SUBJECT: SURRY POWER STATION, UNIT NOS. 1 AND 2 - ISSUANCE OF  
AMENDMENTS REGARDING REACTOR VESSEL HEATUP AND COOLDOWN  
CURVES FOR 48 EFFECTIVE FULL-POWER YEARS (TAC NOS. ME3920 AND  
ME3921)

Amendment No. 274  
Renewed License No. DPR-32

Amendment No. 274  
Renewed License No. DPR-37

SAFETY EVALUATION BY THE OFFICE OF NUCLEAR REACTOR REGULATION

Figure 3.1-1 : Surry Units 1 and 2 Reactor Coolant System Heatup Limitations  
 (Heatup Rates up to 60°F/hr) Applicable for 48 EFPY

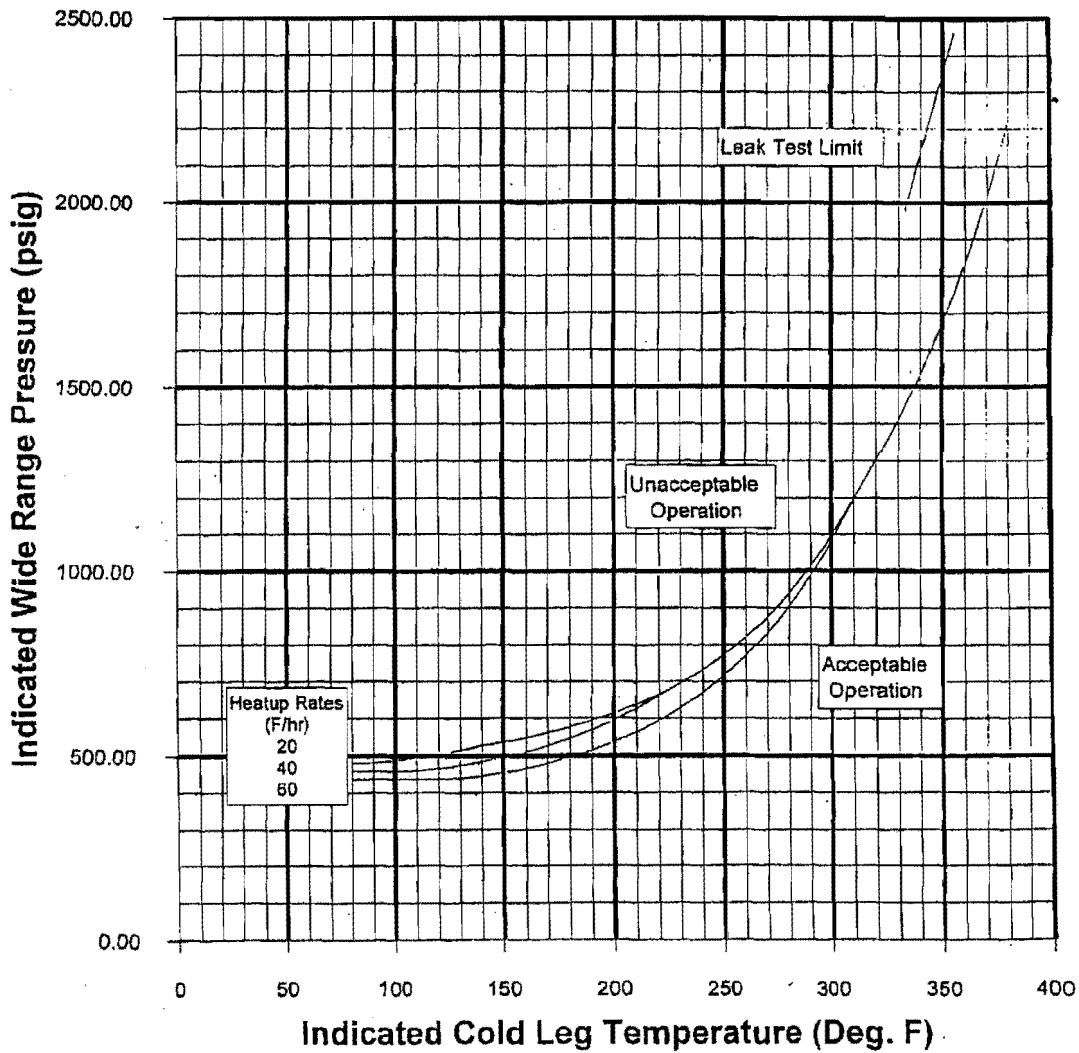
These amendments revise the pressure and temperature limit curves to provide new limits that are valid to 48 effective full-power years for Surry 1 and 2.

The heatup limit curve, Figure 3.1-1, is a composite curve which was prepared by determining the most conservative case, with either the inside or outside wall controlling, for any heatup rate up to 60°F per hour. The cooldown limit curves of Figure 3.1-2 are composite curves which were prepared based upon the same type analysis with the exception that the controlling location is always the inside wall where the cooldown thermal gradients tend to produce tensile stresses while producing compressive stresses at the outside wall. The cooldown limit curves are valid for cooldown rates up to 100°F/hr. The heatup and cooldown curves were prepared based upon the most limiting value of the predicted adjusted reference temperature at the end of 48 EFPY for Units 1 and 2. The adjusted reference temperature was calculated using materials properties data from the B&W Owners Group Master Integrated Reactor Vessel Surveillance Program (MIRVSP) documented in the most recent revision to BAW-1543 and reactor vessel neutron fluence data obtained from plant-specific analyses.

Material Property Basis  
 Limiting Material: Surry Unit 1 Intermediate to Lower Shell Circ Weld  
 Limiting ART Values for Surry 1 at 48 EFPY: 1/4-T, 228.4F  
 3/4-T, 189.5 F
